State of New Mexico
ENVIRONMENT DEPARTMENT

**SUBJECT: APPROVAL WITH MODIFICATIONS
INVESTIGATION WORK PLAN FOR
CAÑON DE VALLE AGGREGATE AREA
LOS ALAMOS NATIONAL LABORATORY
EPA ID # NM0890010515
HWB-LANL-06-019**

Figure 2.9-1. Subaggregate 1 (220 Complex) proposed sampling locations and depths

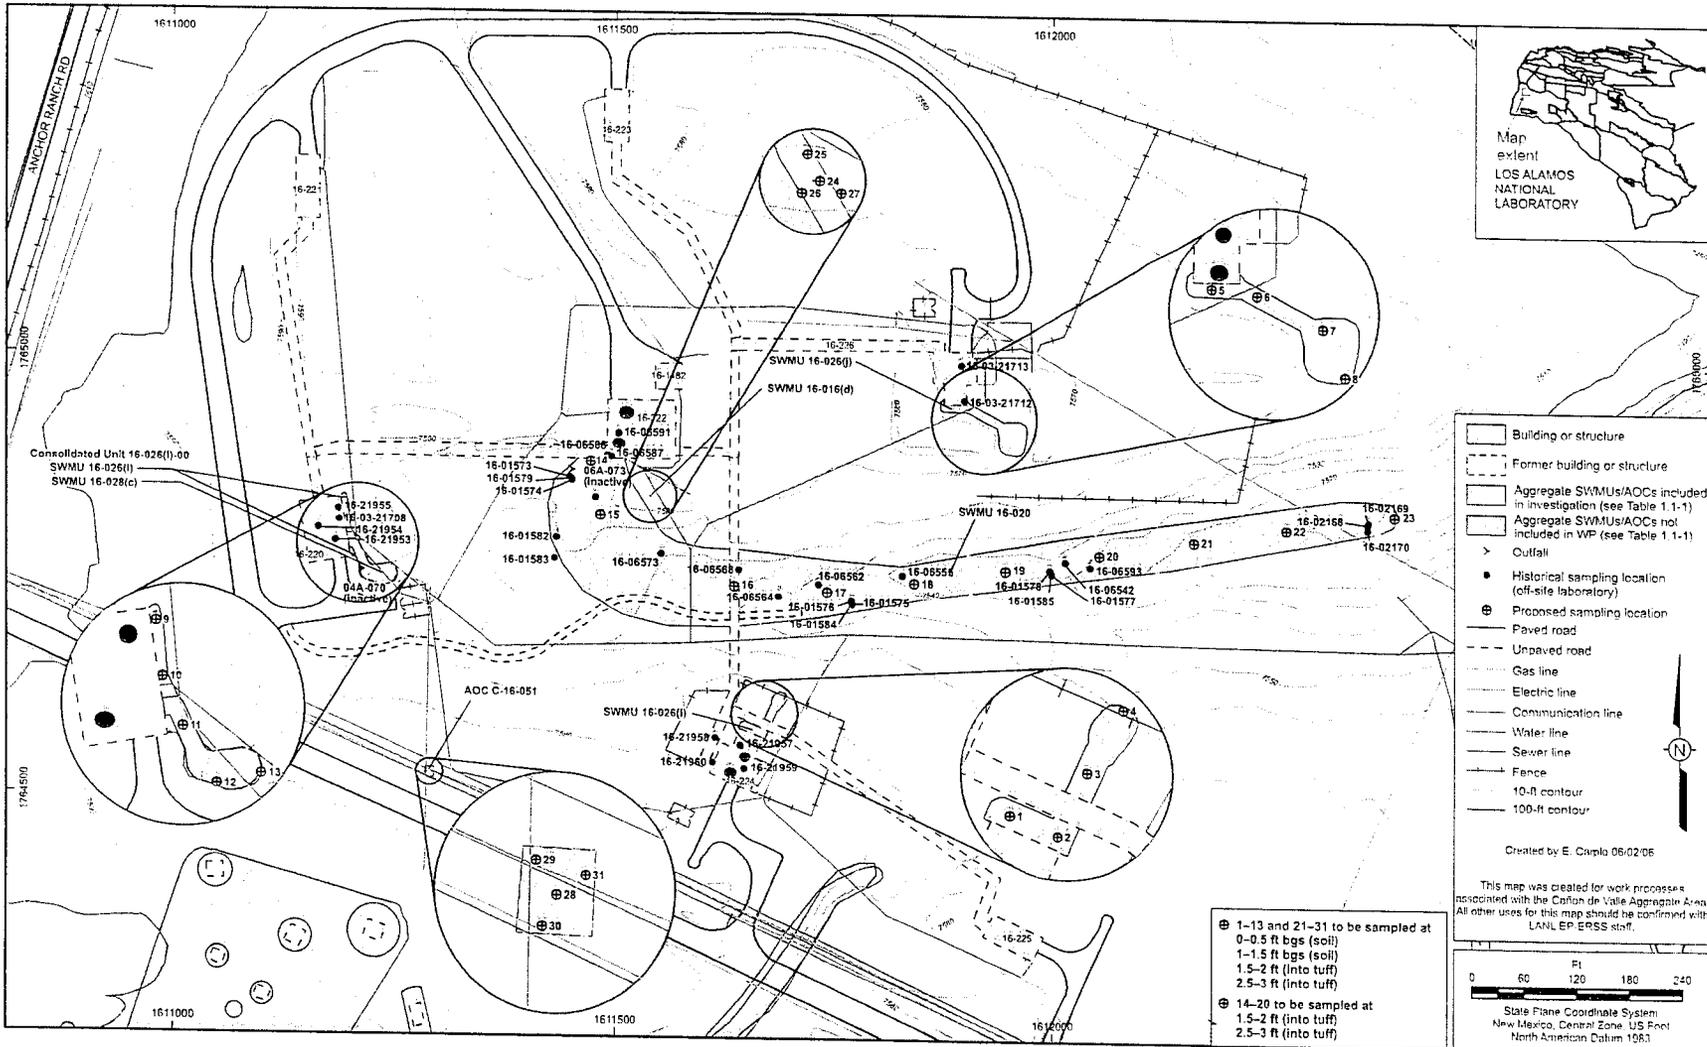
NMED comment: The Permittees must collect additional samples in the footprints of the buildings, if existing data cannot be defended (see comment #4 above). At least two

additional sampling locations must be selected within the footprints of each of the former buildings (i.e., 16-220, 16-224, and 16-226) as shown in the attached map of revised Figure 2.9-1. Samples must be collected near the locations of former drainlines, pipeline connections, sumps, and catchbasins. Samples must be collected from at least two depths at each location, including at the surface and at the fill/native soil or tuff interface.

● NMED required sampling locations

Figure 3.6-1. Subaggregate 2 (MDA R) proposed investigation and sampling locations and depths

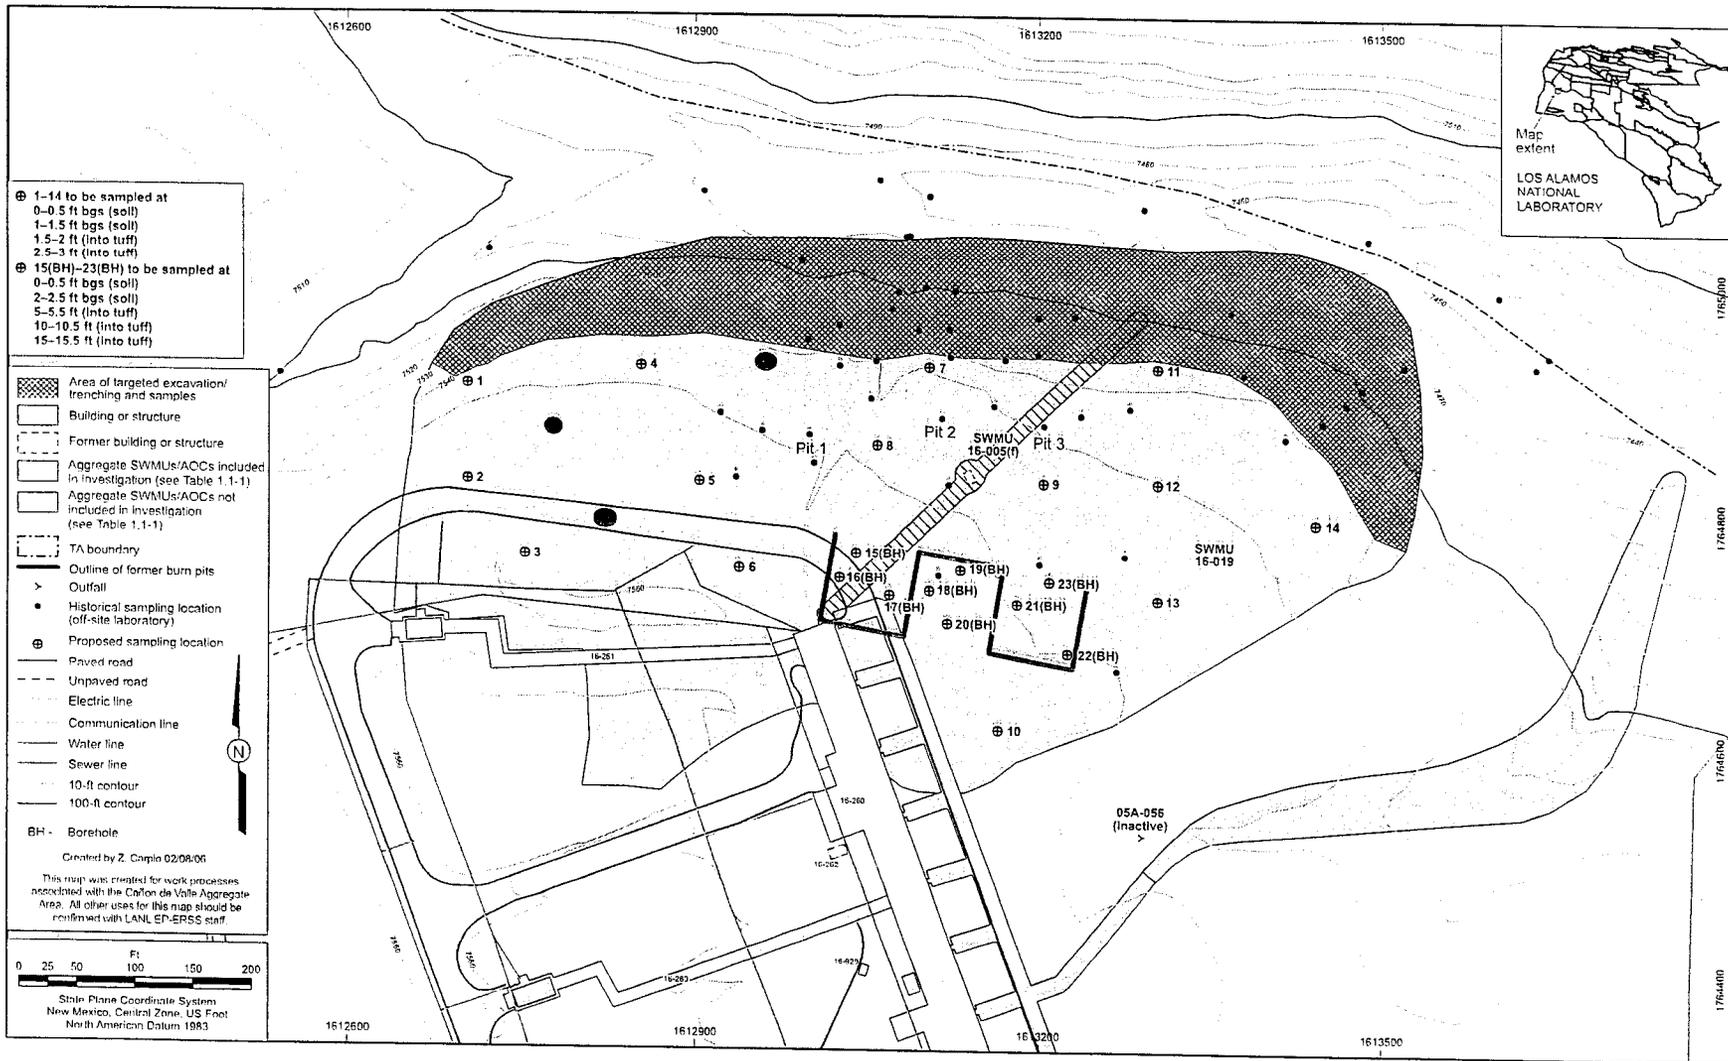
NMED comment: The Permittees have proposed a total sample depth of three feet into the tuff for borings BH1 through BH14, and 15 feet into the tuff for borings BH15 through BH23 at MDA R. The proposed maximum depths may not be sufficient to define the vertical extent of contamination at MDA R. Historical data indicate the presence of contaminants at depth (e.g., RDX, 77 mg/kg at 1.67-2.08 feet at location 16-06508; barium 4500 mg/kg at 2-3 feet at location 16-06511; barium 6800 mg/kg at 3-4 feet at location 16-06506; and lead at 1900 mg/kg at 2.5-5 feet at location 16-06533). In addition to the proposed sampling depths, the

Permittees must collect samples at depths of 7.5 and 10 feet bgs from borings BH1 through BH14.

Borings 1 through 14 are not sufficient to adequately characterize the lateral extent of the landfill. The Permittees must add another sampling location between proposed locations 4 and 7, an additional sampling location in the center of proposed locations 1, 2, 4 and 5, and an additional sampling location between proposed locations 3 and 6 in order to adequately characterize lateral extent, as shown on the attached revised map of Figure 3.6-1. Depth intervals shall be consistent with sample depths required above.

● NMED proposed locations

Figure 7.9-3. Subaggregate 6 (WWII GMX-3 Area East) proposed sampling locations and depths

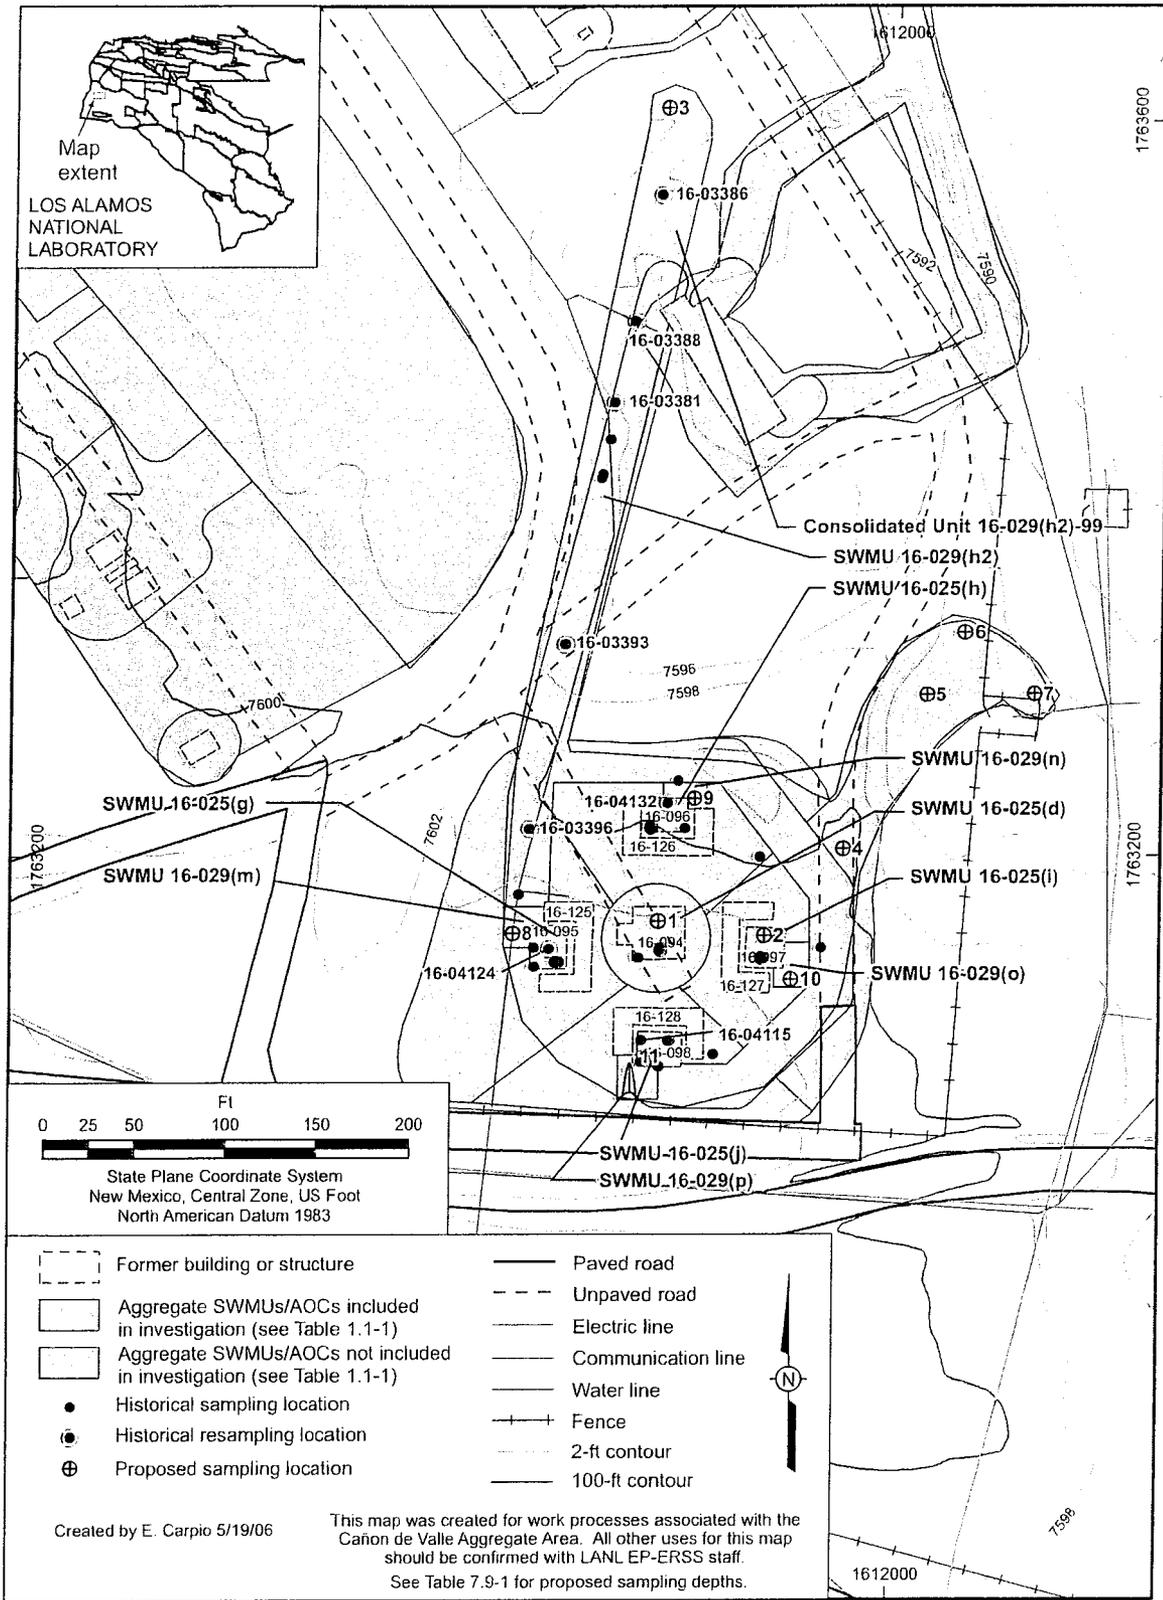
NMED comment: The proposed boring locations at SWMU 16-029(h2)-99 (shown in Figure 7.9-3, page 243) are not adequate for the purposes of characterizing nature and extent of contamination. Only one sample location is proposed at each former building location. This is in contrast to the proposed sampling at consolidated SWMU 16-029(q)-99, shown in Figure 7.9-2 (page 242), which proposes several boring locations for each site. The Permittees must collect at least one additional set of samples (i.e., one additional boring location at four depths, consistent with other proposed sampling) from each of the five former HE machining buildings to further define vertical and lateral extent as shown in the attached map of revised Figure 7.9-3.

In addition, the Permittees must clarify which former structures are indicated by 16-125, 16-126, 16-127, and 16-128. These former structure designations surround the former west, north, east, and south HE machining buildings (i.e., 16-095, 16-096, 16-097, and 16-098), but are not referenced in either the Historical Investigation Report (LANL 2006, 91697) or the Plan.

● NMED required sampling locations

Figure 10.11-2. Subaggregate 9 (TA-15 West) proposed sampling locations and depths: MDA Z

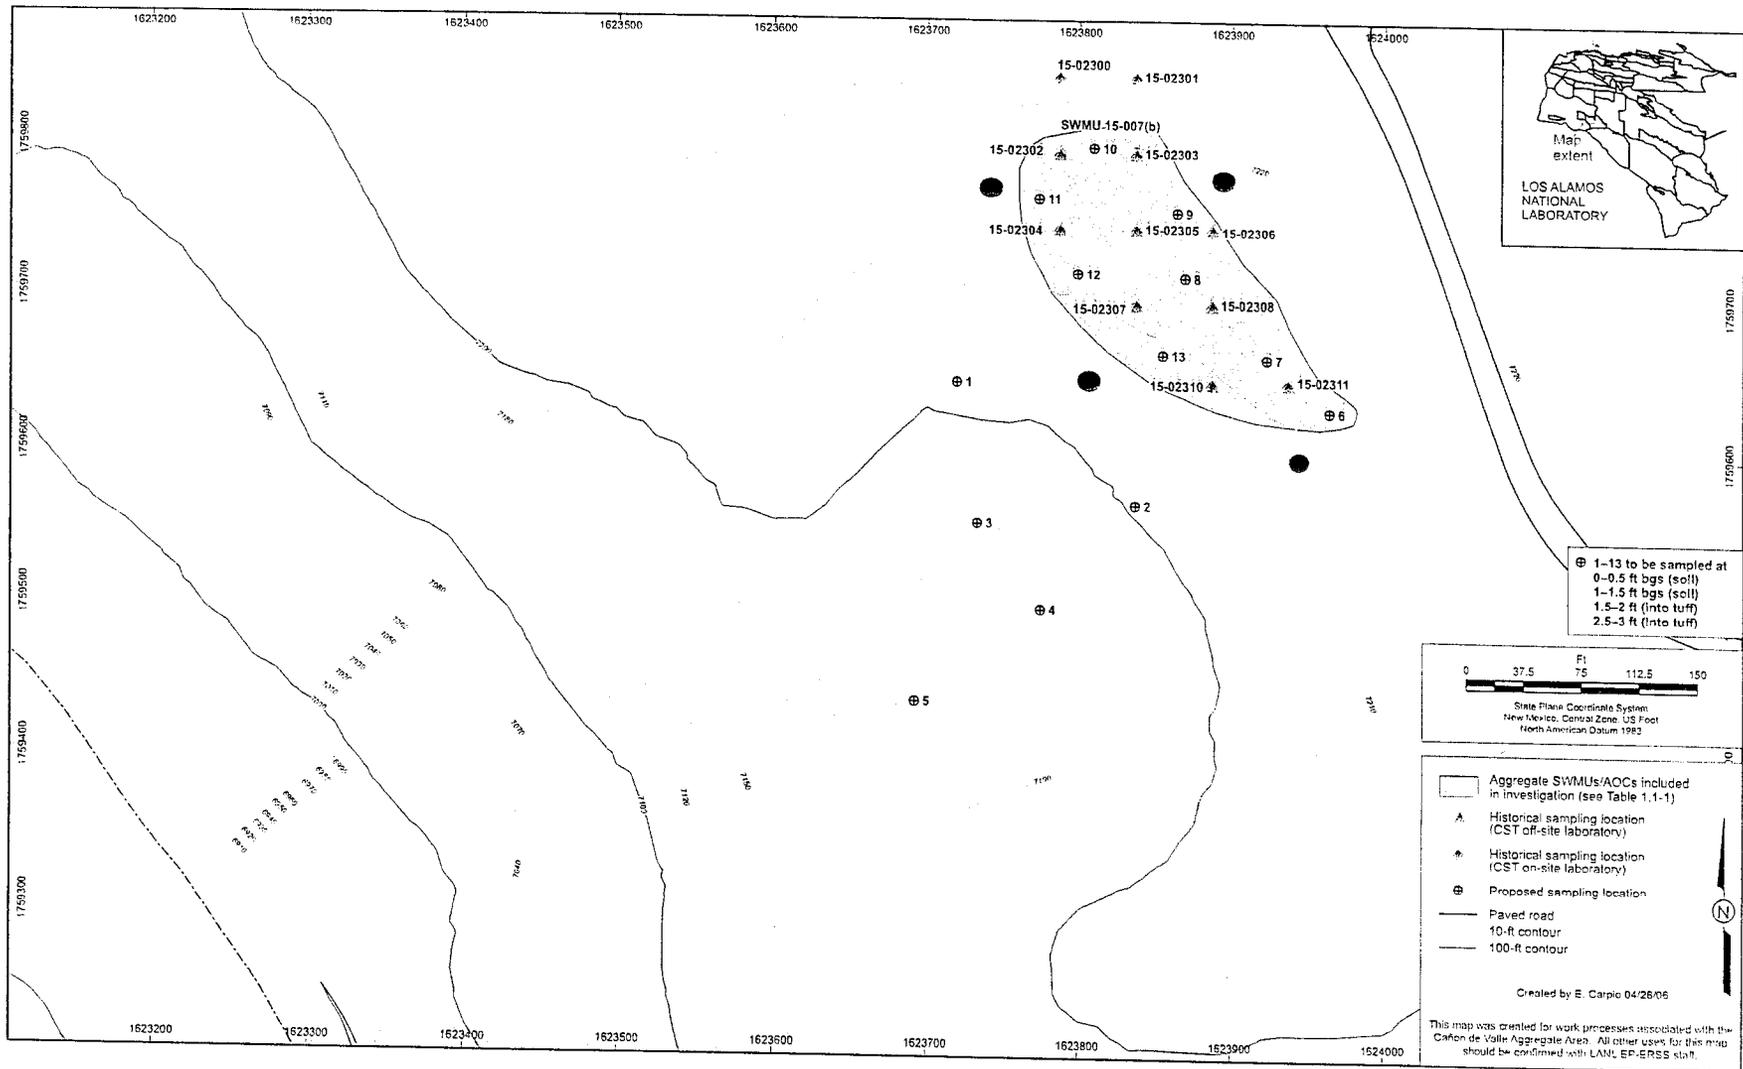
NMED comment: The proposed samples for MDA Z are insufficient to define the extent of contamination. The Permittees must collect additional samples at a minimum of 100 foot intervals in the drainage extending to the toe of the colluvium. Samples must also be collected outside the footprint of the landfill to define lateral extent. See the attached revised map of Figure 10.11-2. If contamination is detected in samples collected from 2.5-3 feet, then the Permittees must collect samples at depths greater than three feet at sampling locations 6 through 13 in accordance with the requirements outlined in the Section IX.B.2.b.i of the Consent Order. Sample locations in the drainage must be selected based on geomorphic relationships and sedimentary packages in accordance with canyon investigation procedures. Justification for the selected sampling locations must be included in the Investigation Report.

Figure 11.7-2. Subaggregate 10 (TA-16-340 Complex) proposed sampling locations and depths: AOC C-16-075

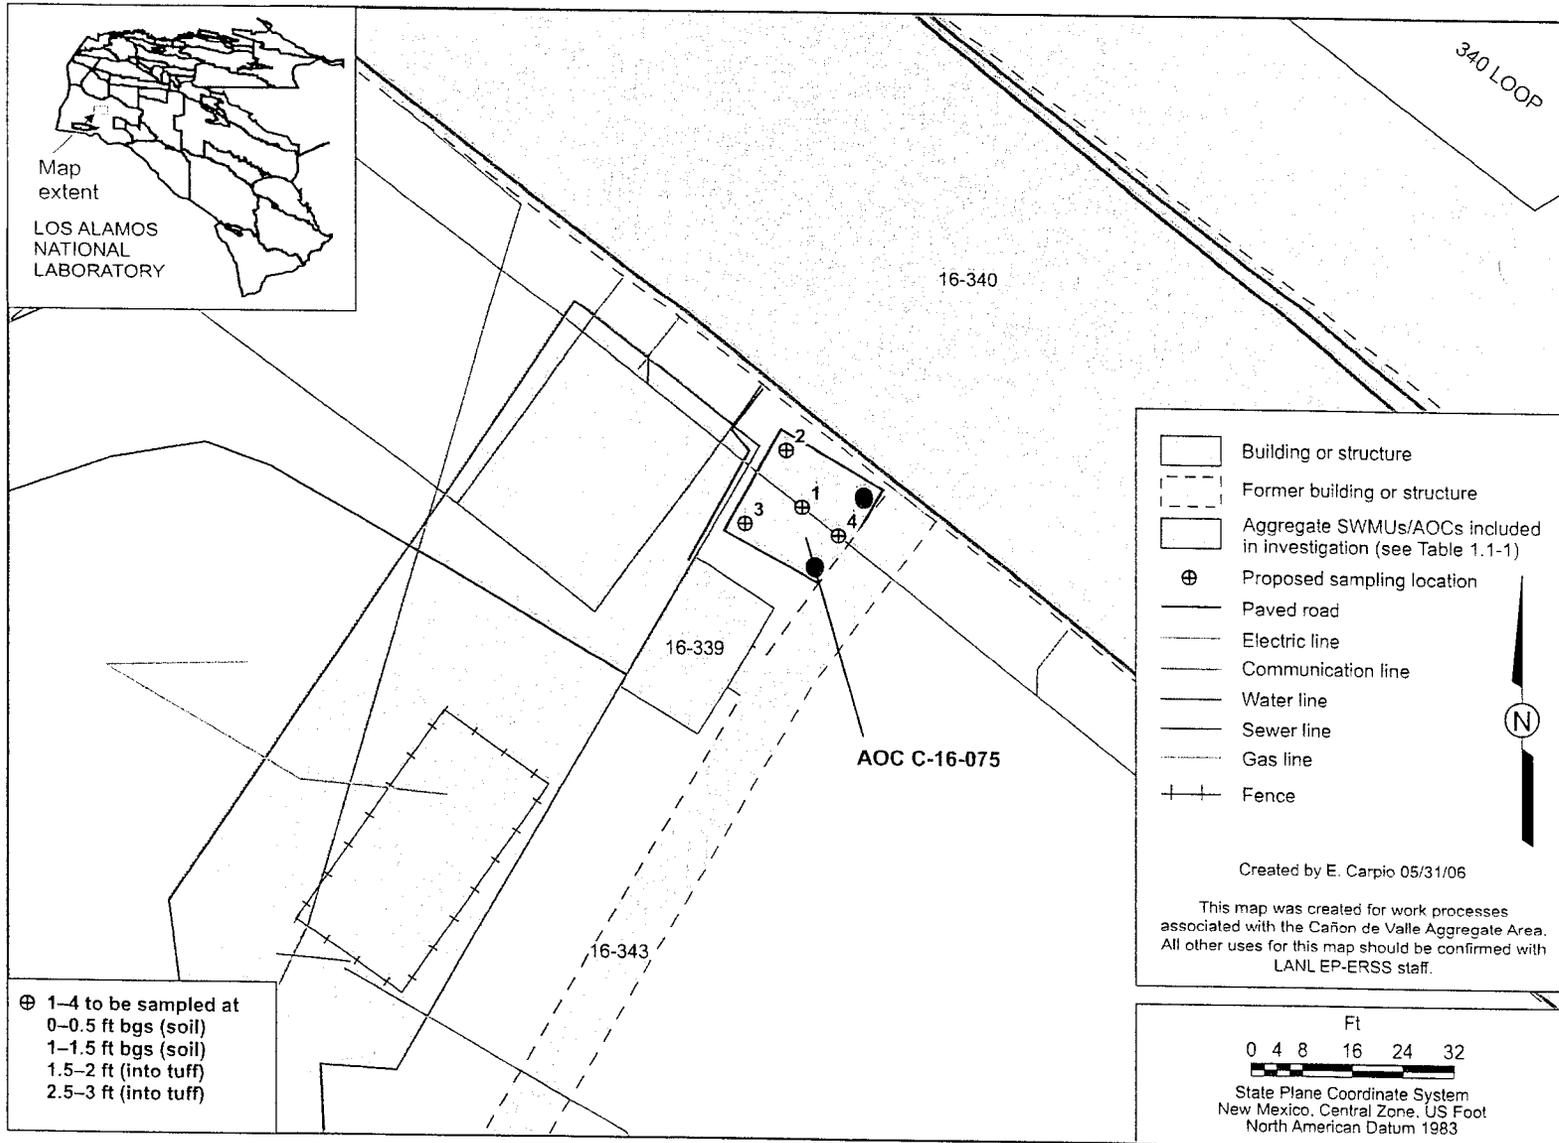
NMED Comment: The proposed sampling locations for AOC C-16-075 are shown in Figure 11.7-2 (page 287). The proposed sampling locations are not adequately distributed over the entire AOC, and there is no explanation as to why the proposed locations were selected. The Permittees must sample the two additional locations shown on the attached revised map of Figure 11.7-2, and provide the rationale behind selection of the borehole locations for AOC C-16-075. See general comment #5 (sampling justification) and general comment #6 (contingency sampling).

● NMED required sampling locations
